Access Compliance Report

Public Rights-of-Way

(Curb Ramps)

Intersection ID: 14779	Main Street: ALBEMARLE_RD	Cross Street: MALLARD_DR	Location: NE
ADA ID: A43509E1E28B	Ramp Type: PerpDiag	Initial Pass/Fail: Fail	Overall Compliance: No
		Severity Score: 12.5

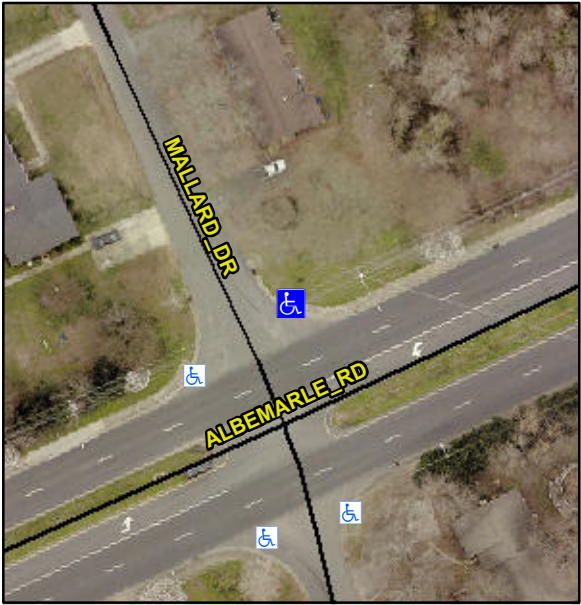
Codes/Mitigation Info/Possible Solution			Field Measurements/Component Compliance		
 <p>Street 1 Name MALLARD DR</p> <p>Stop Condition-Street 2 StopSign</p> <p>Street 2 Name ALBEMARLE RD</p> <p>Stop Condition-Street 1 None</p>	Possible Solutions:		Compliance	Description	Data
	Remove & Replace Curb Ramp With Two New Directional Ramps or Equivalent.		No	Ramp Length (in)	59.0
			Yes	Ramp Width (in)	48.0
			N/A	Flare Type LT	N/A
			N/A	Flare Slope LT (%)	N/A
			N/A	Flare Traversable LT?	N/A
			N/A	Landing Length (in)	N/A
			N/A	Landing Width (in)	N/A
			N/A	Landing Slope (%)	N/A
			N/A	Landing X Slope (%)	N/A
			N/A	Landing Curb? (Y/N)	N/A
			N/A	Shared Landing?	N/A
			N/A	Gutter Ponding?	N/A
			N/A	Gutter Lip Ht (in)	N/A
			No	Painted X Walk1?	N/A
			To W	X Walk 1 Direction	To S
			N/A	X Walk 1 Width (in)	N/A

1.9	X Walk 1 Slope (%)	1.6
			0.5	X Walk 1 X Slope (%)	2.4
			N/A	Ramp inside XWalk1?	N/A
<p>Surveyor Notes:</p> <p>N/A</p> <p>PROW/ADA:</p> <p>Not Found, R304.2.2</p> <p>Total Cost: \$ 3200.00</p>			N/A	Ramp inside XWalk2?	N/A
